LETTER OF OBJECTION to Planning Application 2023/5338/P and Listed Building Consent 2024/0091/L.

Site Address: Alexandra Road Estate, Rowley Way, London NW8 0SN

‘Replacement of the existing estate-wide heating distribution infrastructure including removal of redundant pipework; installation of two new sub-plant rooms; installation of cold-water storage tank rooms; replacement of existing site hoarding and installation of new replacement infrastructure pipework.’

Photo of the existing concrete fins from report

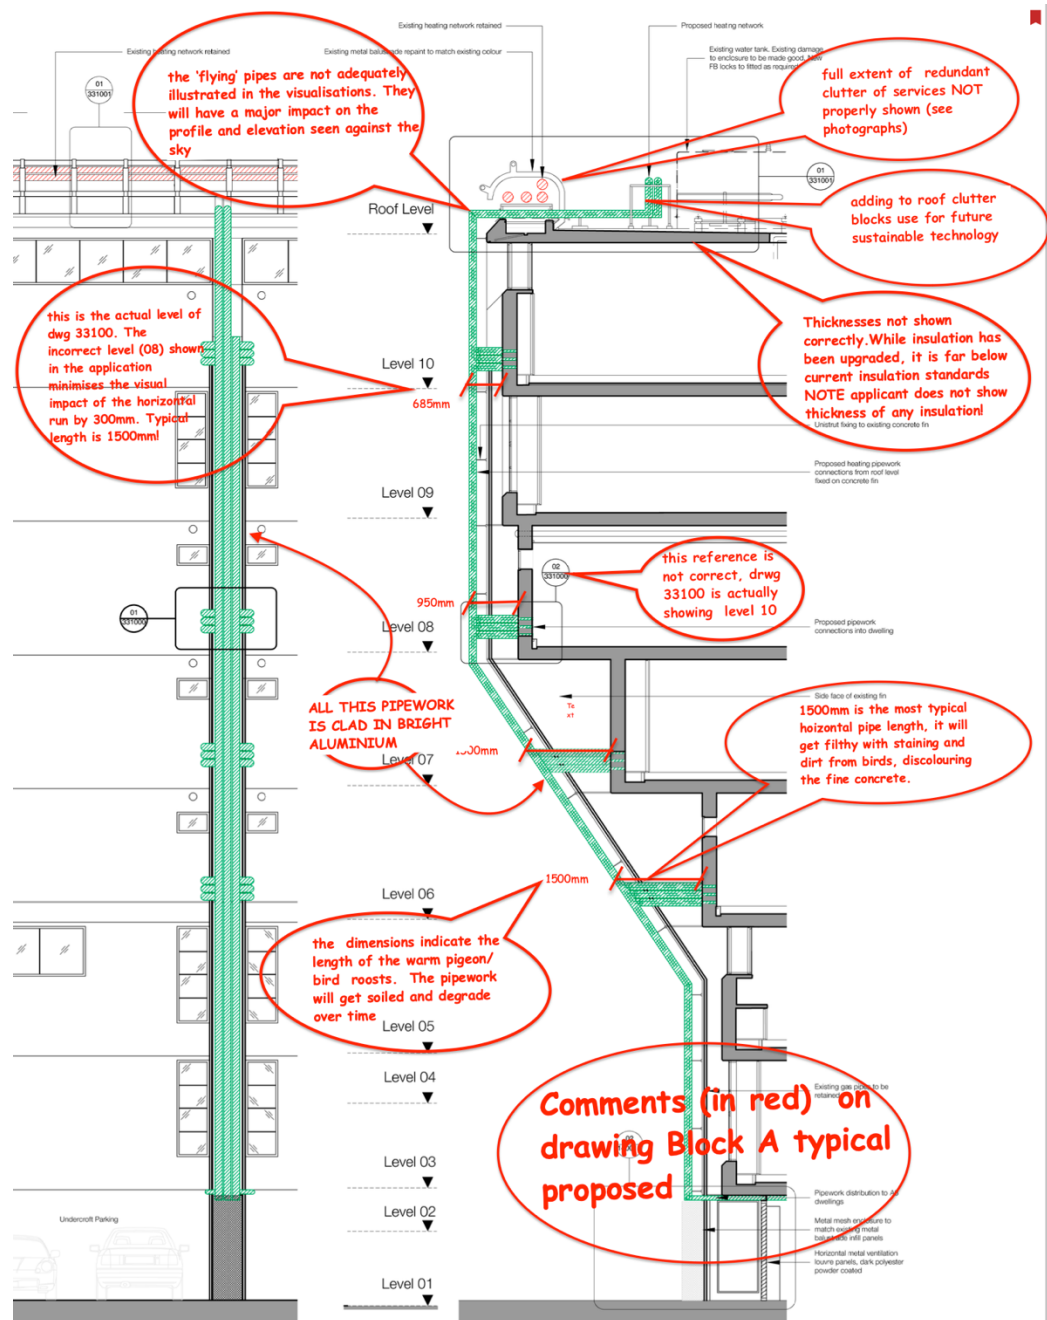
- e) The application proposes that the new distribution pipe work will run vertically up **every other** concrete fin. This pipework will then be covered with bright aluminium casings destroying the homogenous architectural feature and the rhythm of this facade.

This is clearly shown by the technical drawings and CGI illustrations submitted in the application showing the unsightly pipe work somehow bathed in sunlight on a north elevation whereas it is more likely to be covered in pigeon poo.

The illustrations are misleading as they only show a view from the low-level service road. The angle of view also masks the awkward disfiguring set back at the top floor which will have a huge visual impact when seen from the public realm.

The elevation will be radically and irreversibly altered, and heritage destroyed.

- i) **8.3 Proposed Materials - Typical**

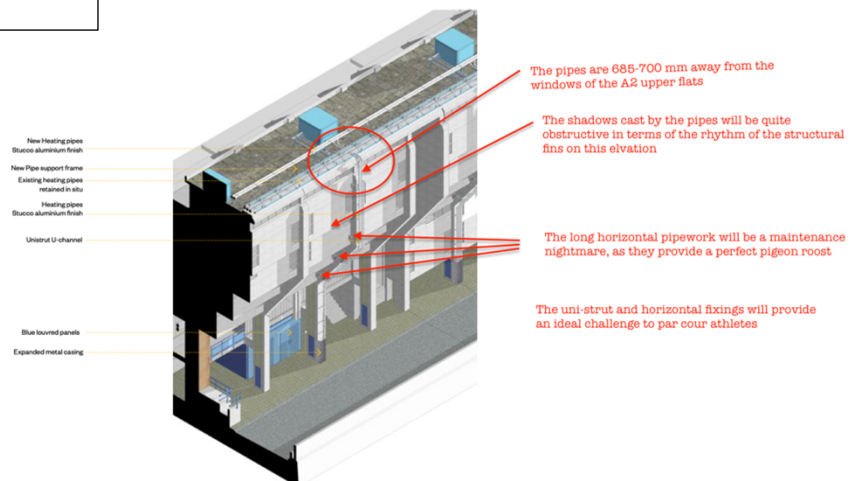
This low resolution drawing starts to illustrate the visual destruction of the iconic elevation facing the railway
